2nd Addendum to the Environmental Impact Report on the
Natomas Levee Improvement Program
Landside Improvements Project—Phase 2 Project

State Clearinghouse # 2007062016

SECOND ADDENDUM TO THE PHASE 2 LANDSIDE EIR

Plate 1

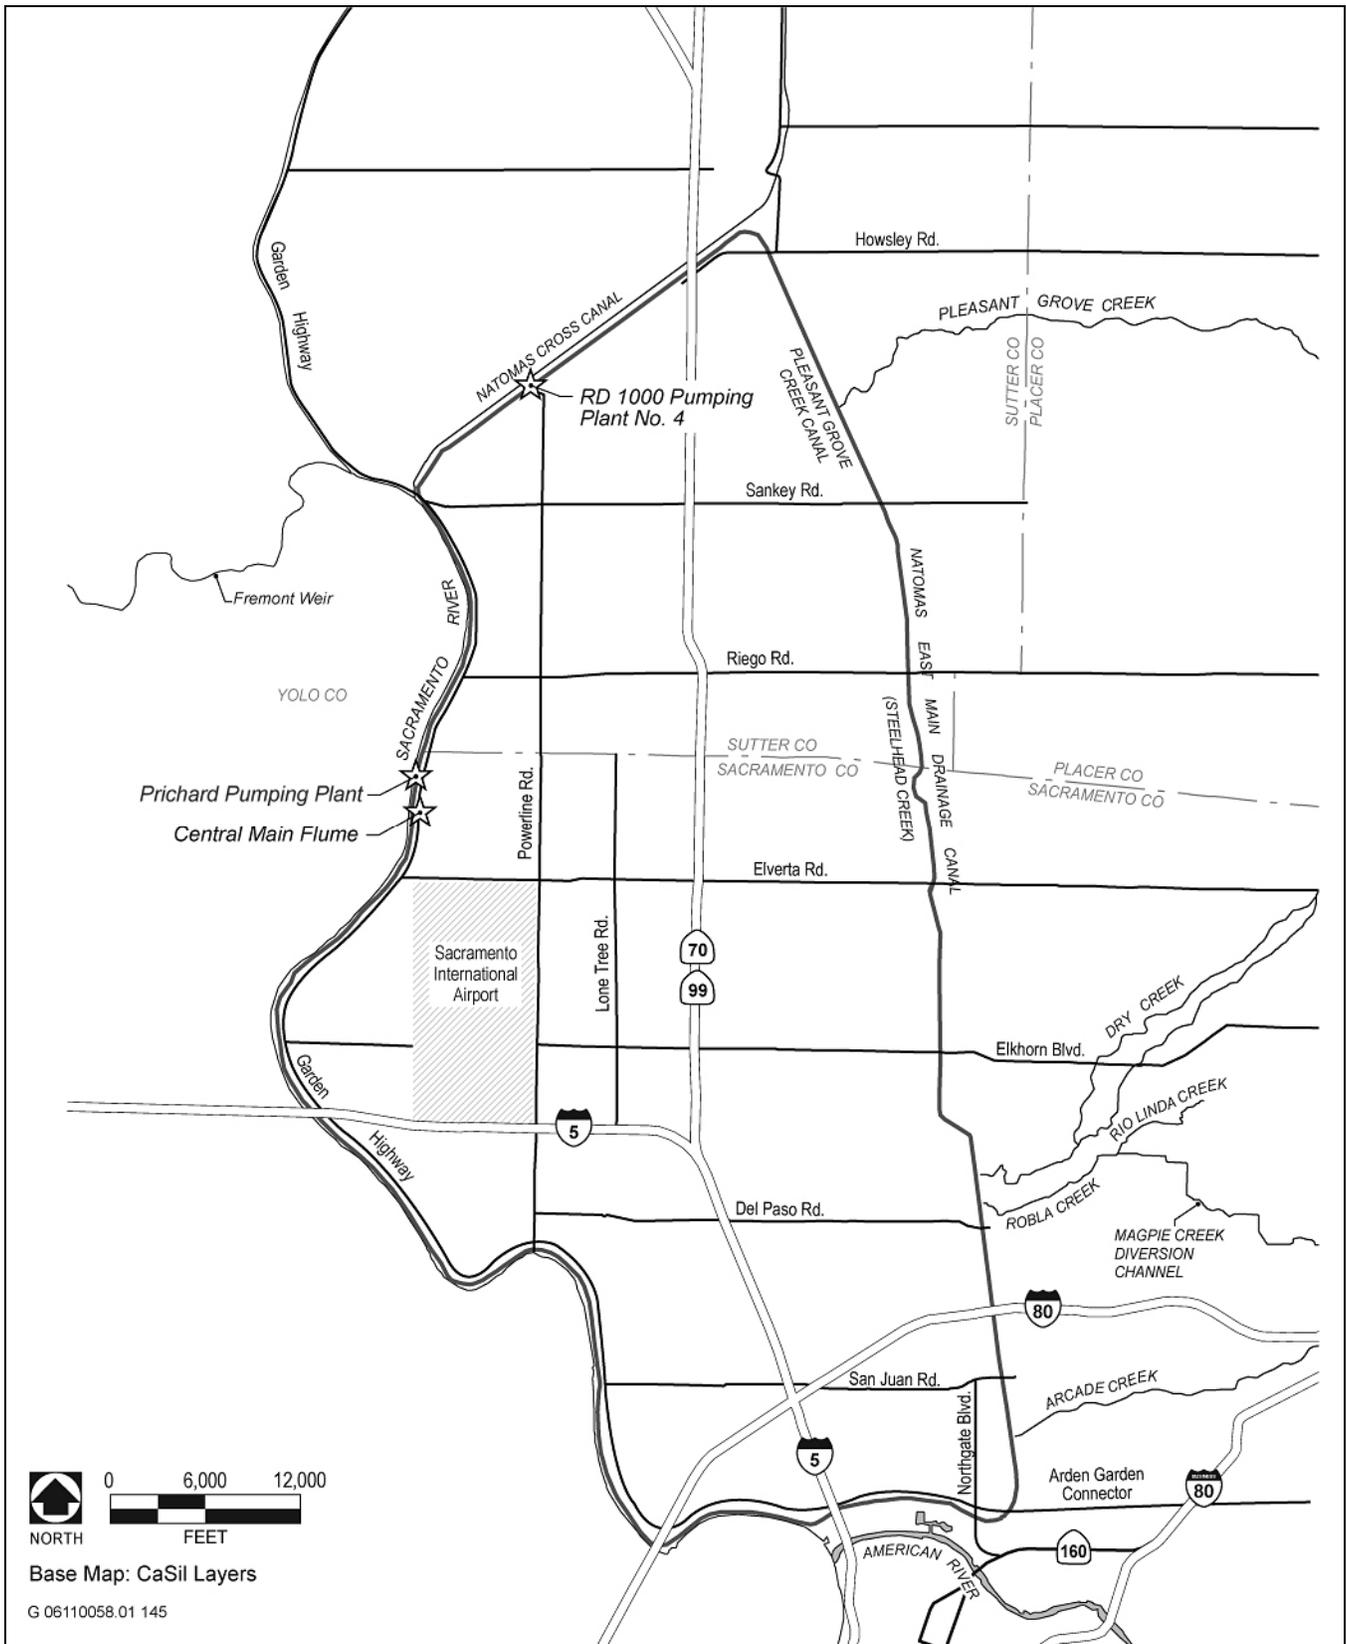
In the 2007 Landside EIR, SAFCA described three actions as part of the program. First, as part of the Phase 2 Project, SAFCA described the need to raise the outfall pipes for Reclamation District (RD) 1000 Pumping Plant No. 4, which cross the Natomas Cross Canal (NCC) south levee in Reach 2 and discharge into the NCC (SAFCA 2007:2-22). SAFCA also identified the need to remove encroachments on the landside of the Sacramento River east levee (SAFCA 2007:2-60). In addition, SAFCA identified the need to extend the pipes connecting the Prichard Pumping Plant and the realigned Elkhorn Canal, which would require vegetation removal (SAFCA 2007:2-38). The locations of these activities are depicted in **Plate 1**.

Minor changes in the implementation of these actions are proposed. First, as part of raising the RD 1000 Pumping Plant No. 4 outfall pipes as described in the 2007 Landside EIR, SAFCA proposes to replace the outfall structure at the location where the outfall pipes enter the NCC. This would require the construction of a cofferdam on the waterside of the NCC south levee to dewater the area surrounding the outfall. This cofferdam would be constructed in the NCC channel. Second, the 2007 Landside EIR project description did not specifically identify the Central Main Flume as a landside utility facility that must be removed. SAFCA must remove the westernmost segment of this feature between the toe of the existing Sacramento River east levee and the eastern edge of the realigned Elkhorn and Giant Garter Snake (GGS)/Drainage Canals to construct the adjacent levee and seepage berm and to remove what would otherwise be a remnant section of the flume between the seepage berm and the canals. Third, the extension of the pipes connecting the Prichard Pumping Plant and the Elkhorn Canal would require removal of slightly more vegetation than described in the 2007 Landside EIR and the SEIR. Because these actions constitute project changes, SAFCA has prepared this addendum to the 2007 Landside EIR as supplemented.

Plate 2

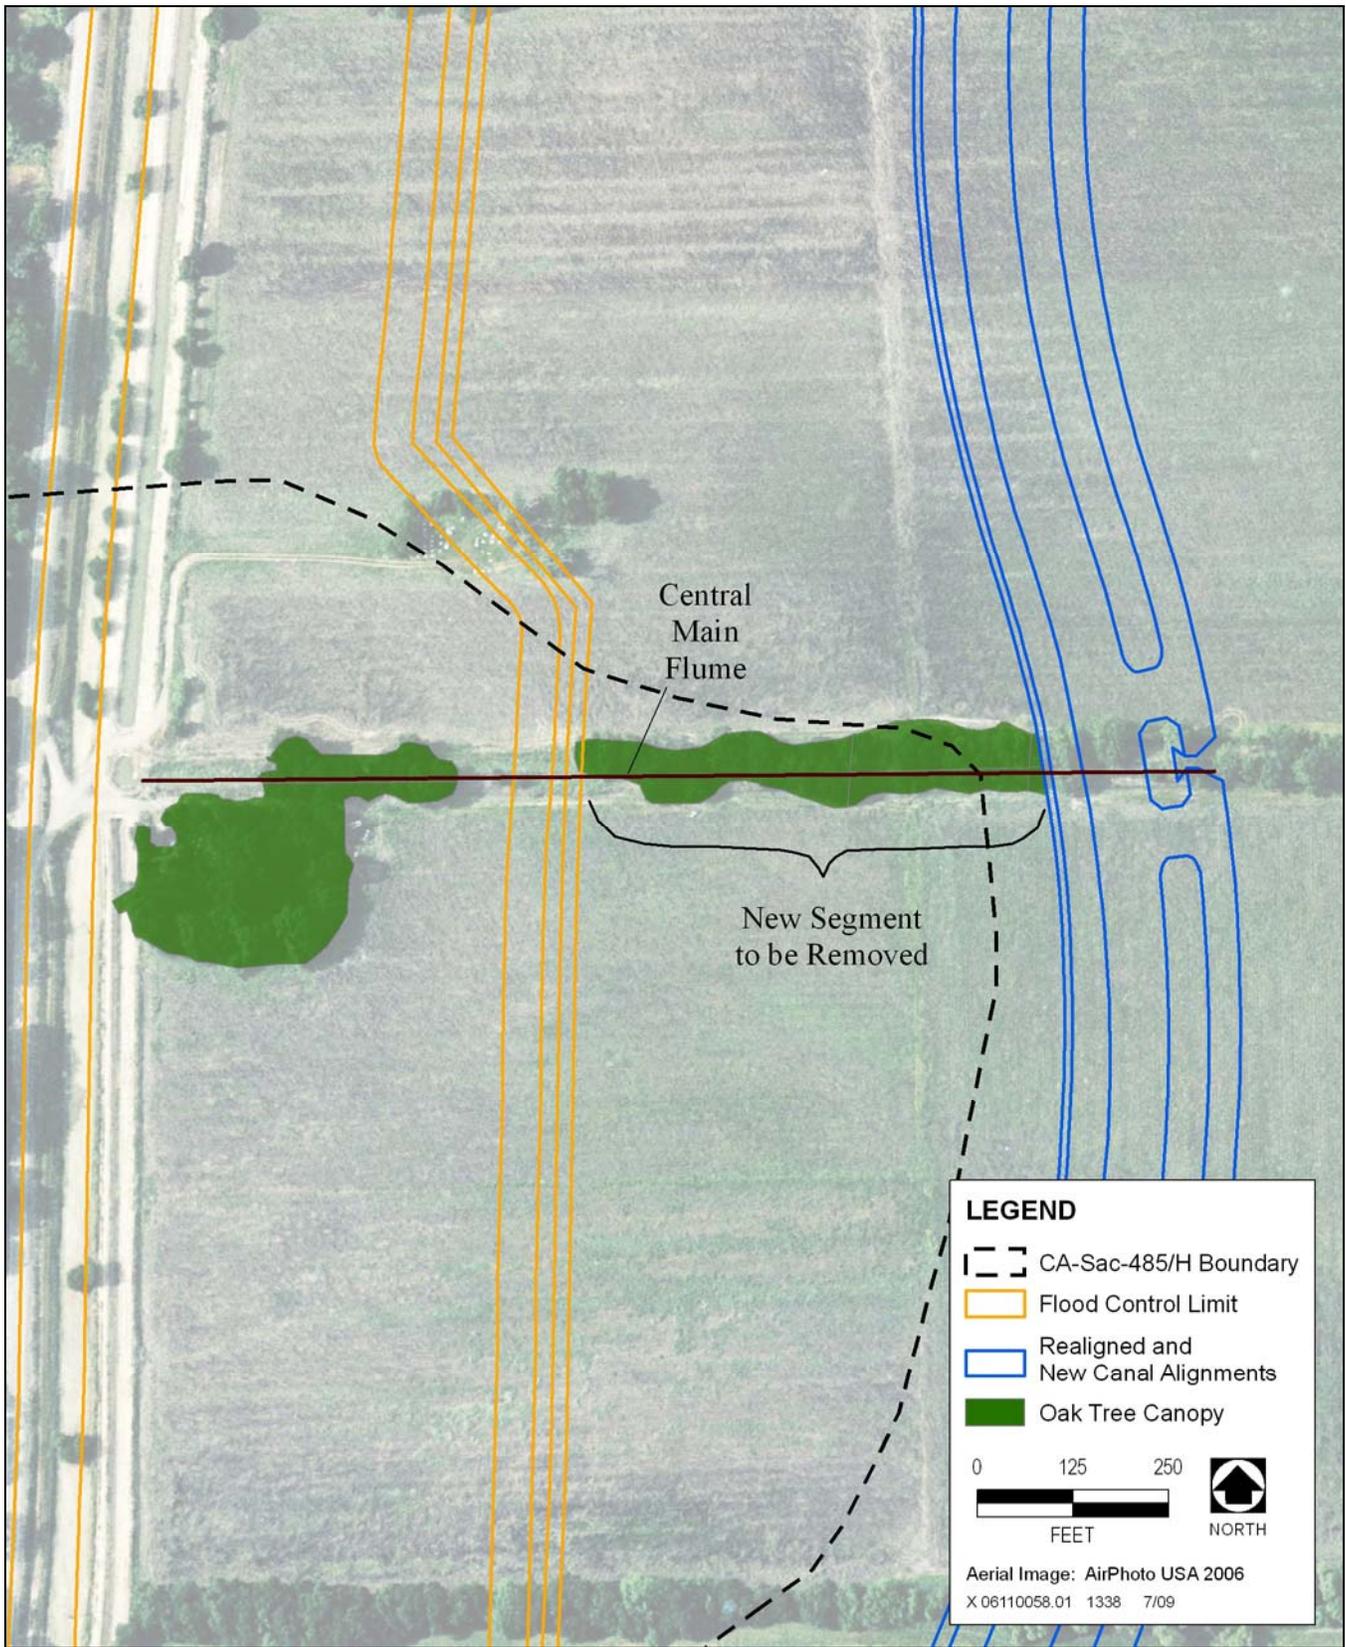
The Central Main Flume consists of an approximately 10-foot-wide concrete-lined highline channel that conveys water from the current alignment of the Elkhorn Canal to water users to the east. Because the Elkhorn Canal is in the footprint of proposed improvements to the Sacramento River east levee, the canal would be moved east, parallel to the proposed alignment of the GGS/Drainage Canal. The segment of the Central Main Flume west of the realigned Elkhorn and GGS/Drainage Canals would be dewatered and removed because it would be obsolete (**Plate 2**). A portion of this flume is located under the footprint of the proposed improvements to the Sacramento River east levee; impacts associated with removal of the segment inside the footprint of Sacramento River east levee improvements and the realigned Elkhorn and GGS/Drainage Canals are not further analyzed in this addendum because those impacts were disclosed in the 2007 Landside EIR as supplemented.

The Central Main Flume is a concrete-lined flume that was constructed on an earthen berm slightly above the existing grade. The 2007 Landside EIR described impacts associated with resources that are in the footprint of the Sacramento River east levee improvements, including resources such as woodlands adjacent to the flume. The impacts disclosed in the 2007 Landside EIR as supplemented include resources along the flume that are in the footprint of the Sacramento River east levee and resources in the footprint of the realigned Elkhorn and GGS/Drainage Canals, where the flume and other encroachments would be removed. SAFCA has identified approximately 625 additional feet of the flume (between the two previously identified segments) that would need to be removed (**Plate 2**). The concrete lining of the flume would be broken into rubble and removed by an excavator or other piece of heavy equipment working from one side of the flume. Existing trees along the sides of the flume would be felled to allow for equipment access to the flume, and the stumps would be cut to be level with the existing grade and painted with an herbicide to prevent resprouting. After the concrete is removed, the remaining flume cross section would be filled with imported earthen material, and the flume alignment would be capped with the same imported fill to provide a cover over any potential cultural resources that may be present in the earthen berm material. The contractor would use low-ground-pressure equipment and would construct the cap so that the equipment is working on a surface of imported fill rather than on the surface of cultural deposit CA-Sac-485/H (see **Plate 2** for site boundaries).

Several resources would be affected by work at the Central Main Flume. To remove the flume and construct a berm over the flume alignment, it would be necessary to remove oak trees on both sides of the flume. It would also be necessary to fill local drainage ditches, located along the flume, that have been determined to be waters of the United States subject to regulation by the U.S. Army Corps of Engineers (USACE) under the Clean Water Act (jurisdictional features). While it may be possible to remove trees from one side of the flume only, this addendum conservatively estimates that trees on both sides might be removed. These features would be removed and/or filled as a result of the proposed work at the central section of the Central Main Flume. The affected acreages are provided in **Table 1**.
